ADDENDUM NO. 3

**PROJECT NAME:** CV STARR INTERMEDIATE SCHOOL

CAFETORIUM ADDITION, INTERIOR RENOVATIONS & RELATED WORK

DATE: January 9, 2025

1 ROOF PLUMBING PLAN - STORM WATER
SCALE: 1/8" = 1'-0"

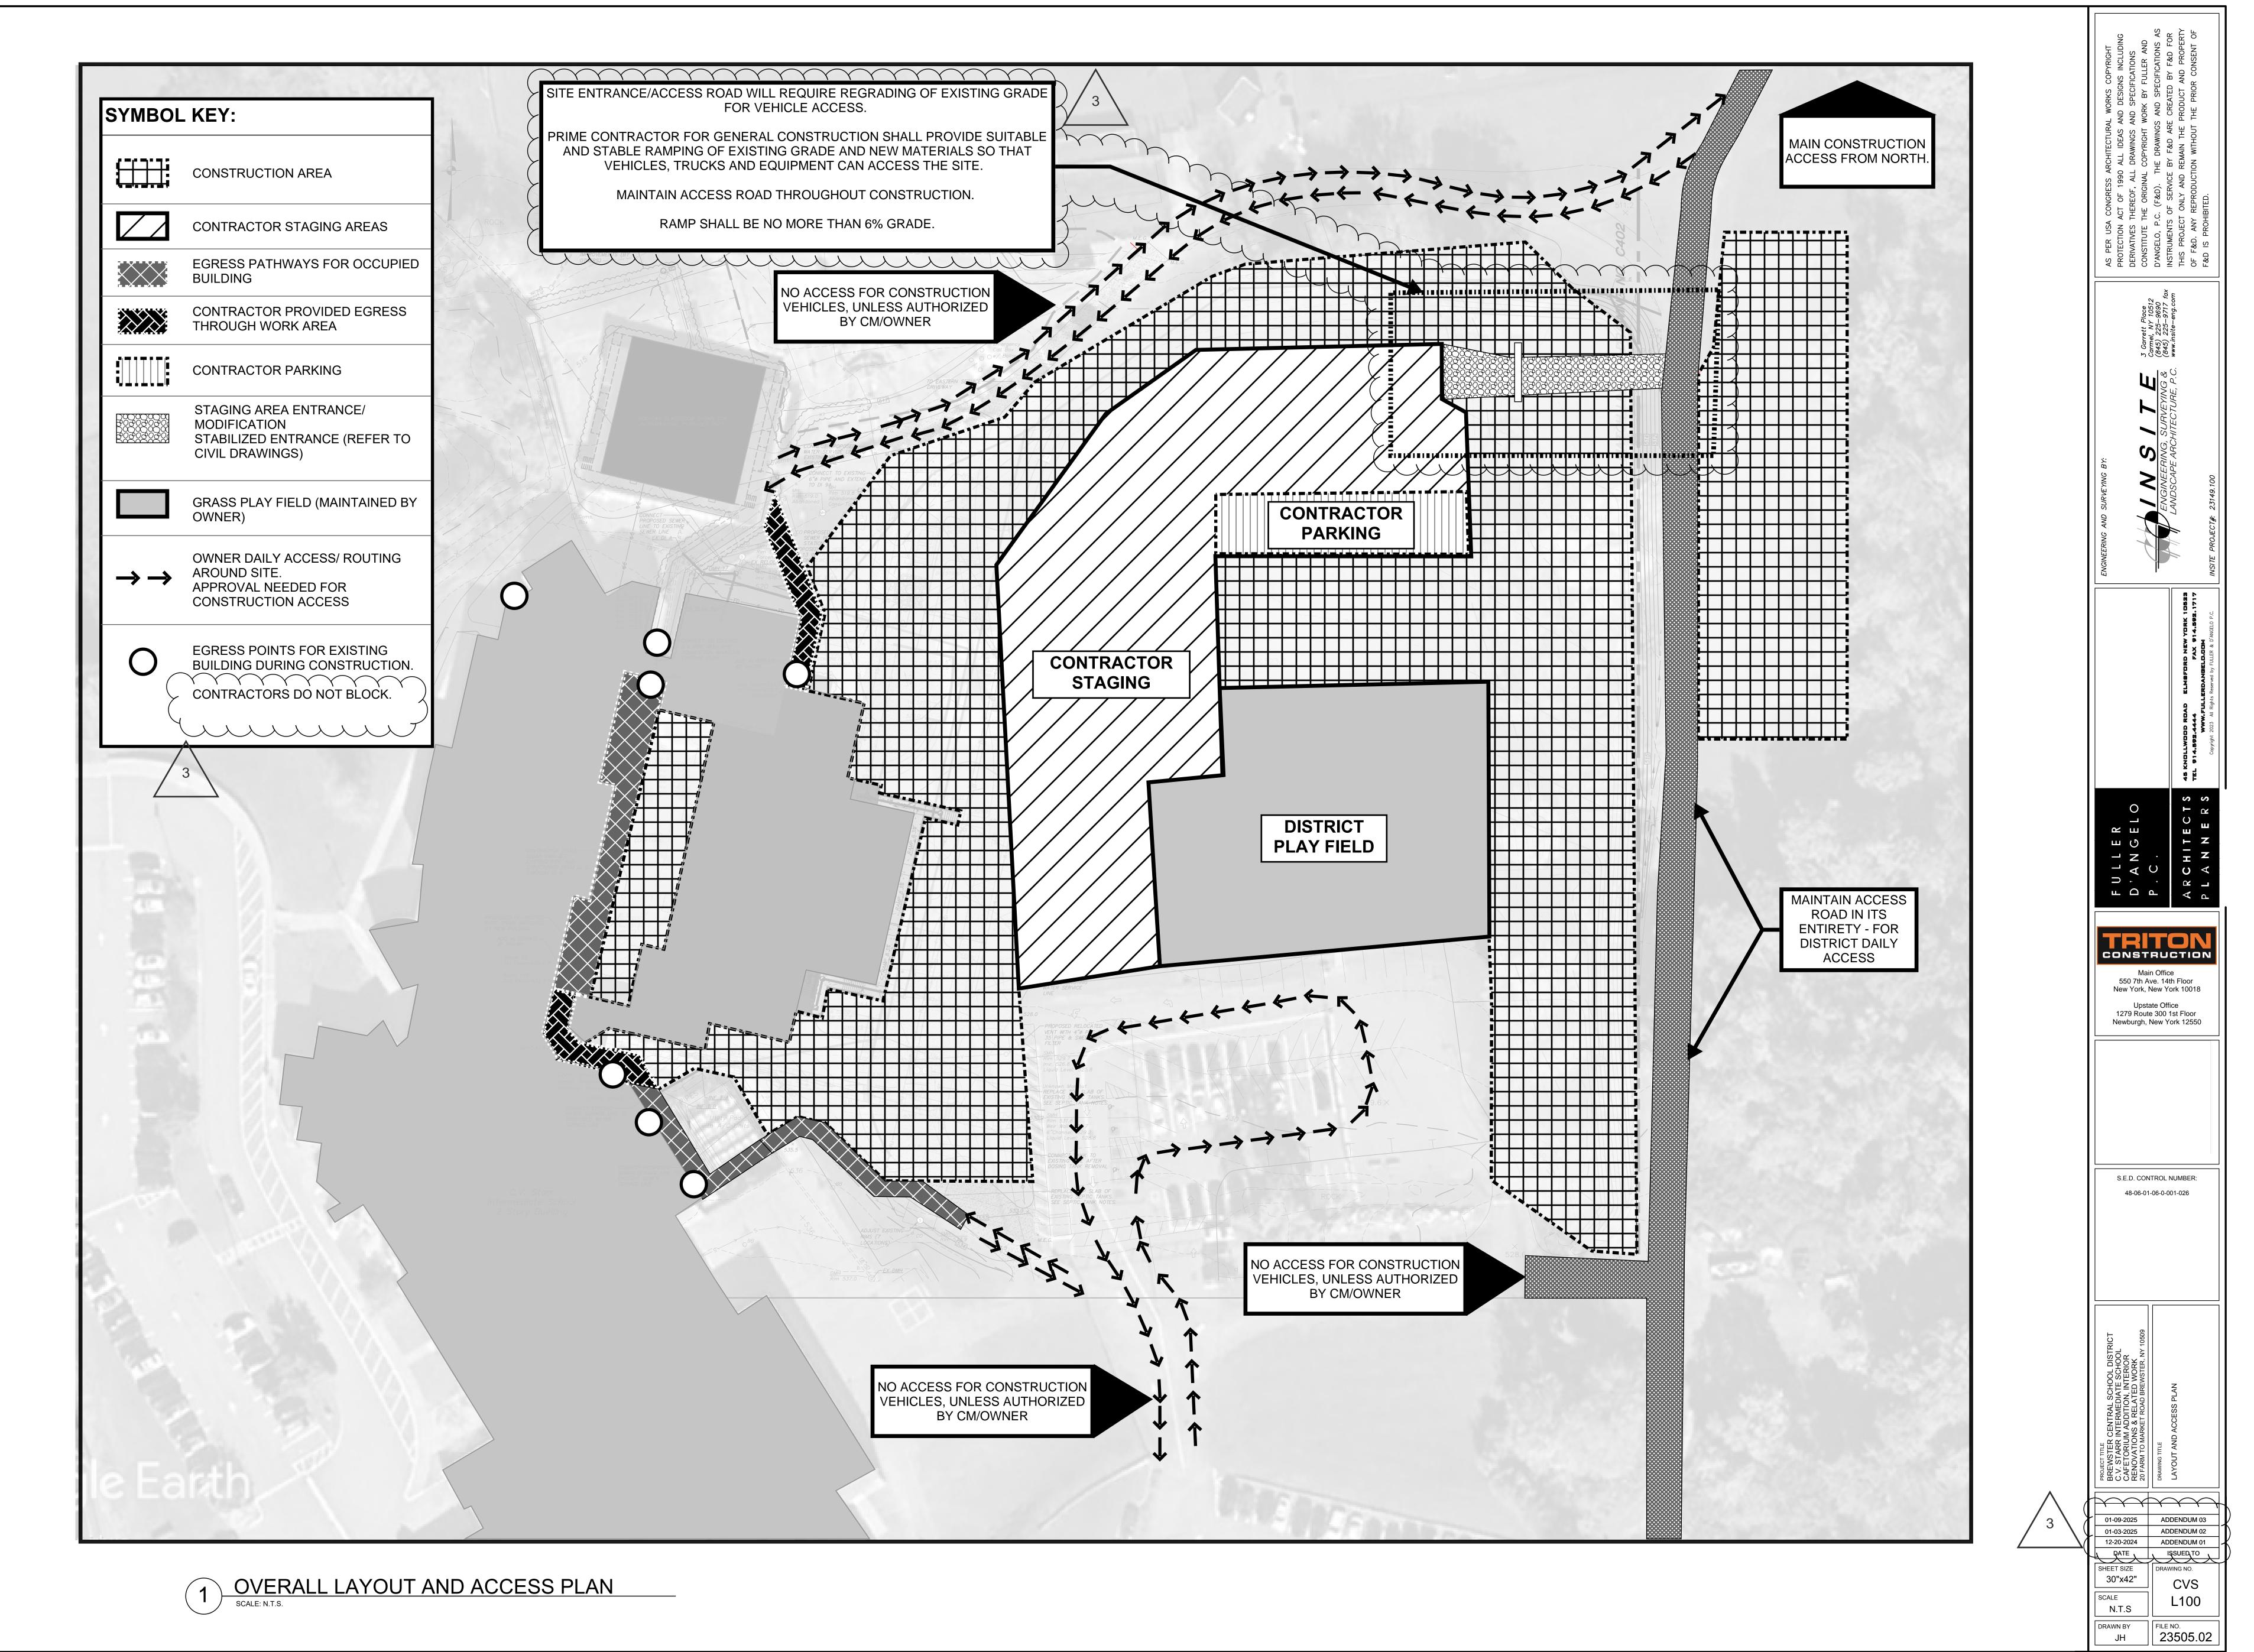
DISCIPLINE/TRADE DWG./SPEC. REFER QUESTION: My esi sheet P103 for co	: Plumbing  ENCE: Drawing Plan P-Alt P-1 a  timator tells me that Plan P-Alt P-	ind P103 1 States "see base bid work
DISCIPLINE/TRADE DWG./SPEC. REFER QUESTION: My esi sheet P103 for col drainage shown	: Plumbing  ENCE: Drawing Plan P-Alt P-1 a  timator tells me that Plan P-Alt P-  ntinuation" now P103 is all gas pi	and P103 1 States "see base bid work pe work, there isnt any storr
DISCIPLINE/TRADE DWG./SPEC. REFER QUESTION: My est sheet P103 for col drainage shownFIELD CONDITION	e: Plumbing  ENCE: Drawing Plan P-Alt P-1 a  timator tells me that Plan P-Alt P-  ntinuation" now P103 is all gas pip	and P103 1 States "see base bid work pe work, there isnt any stori
DISCIPLINE/TRADE DWG./SPEC. REFER QUESTION: My esi sheet P103 for cod drainage shown FIELD CONDITIODRAWING/SPEC	ENCE: Drawing Plan P-Alt P-1 a timator tells me that Plan P-Alt P-ntinuation" now P103 is all gas pipon_	and P103 1 States "see base bid work pe work, there isnt any stori

2 VESTIBULE 34 MAINTAINED EGRESS
SCALE: N.T.S.

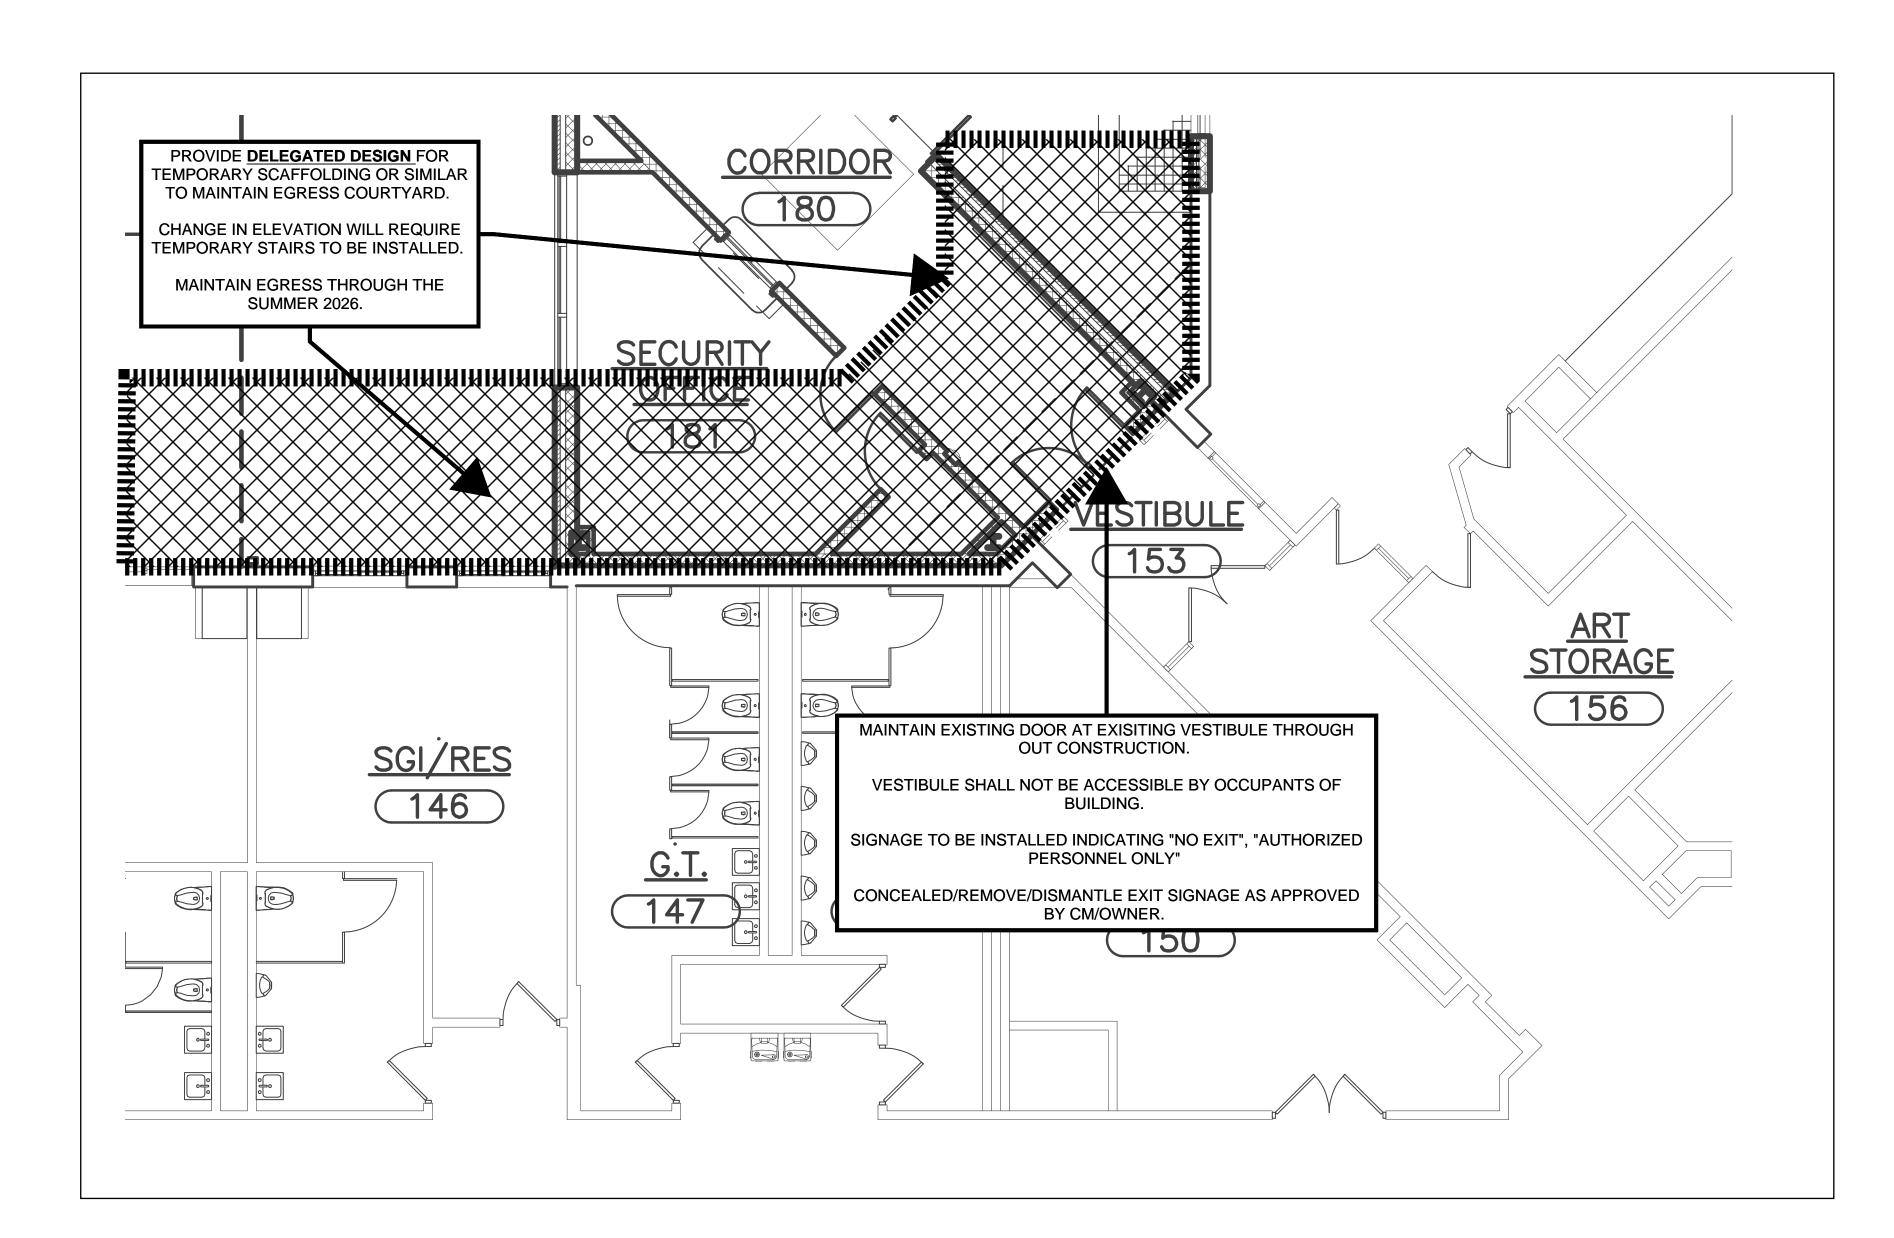
a. New Page detailing Interior Logistics, Temporary Walls and Egress.

CVS
PH100

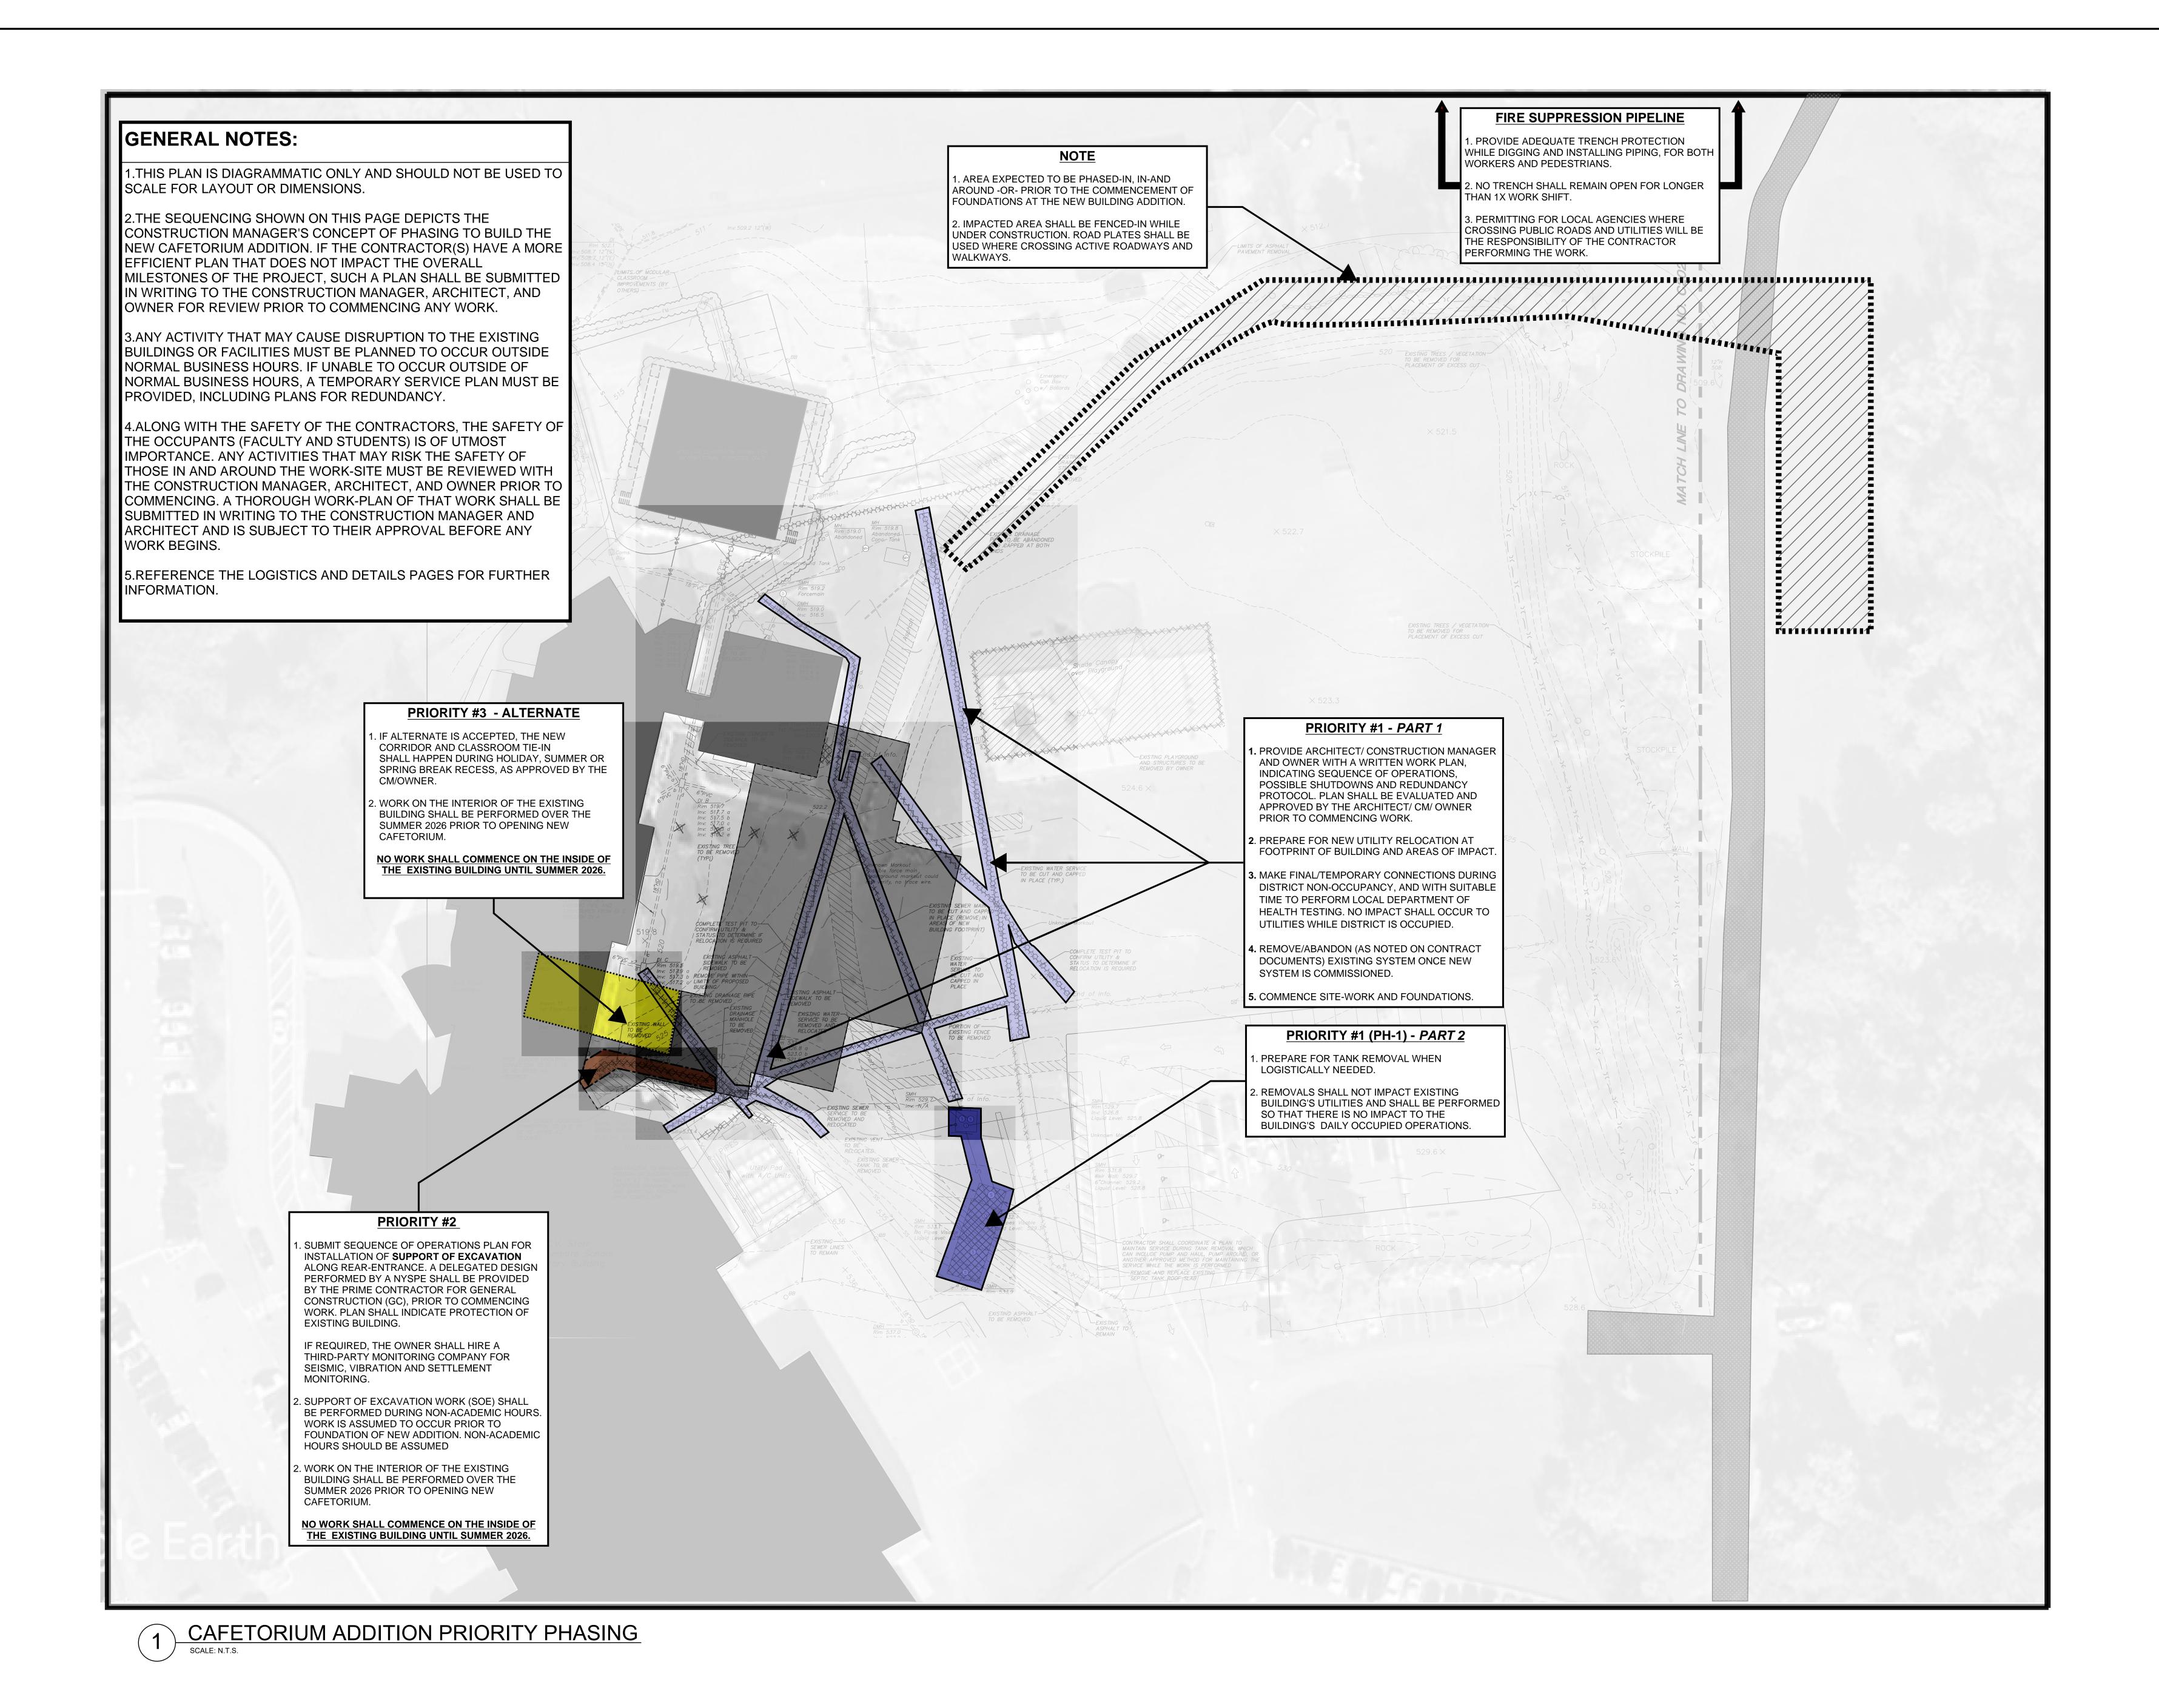
**ADD** drawing attached to this addendum.
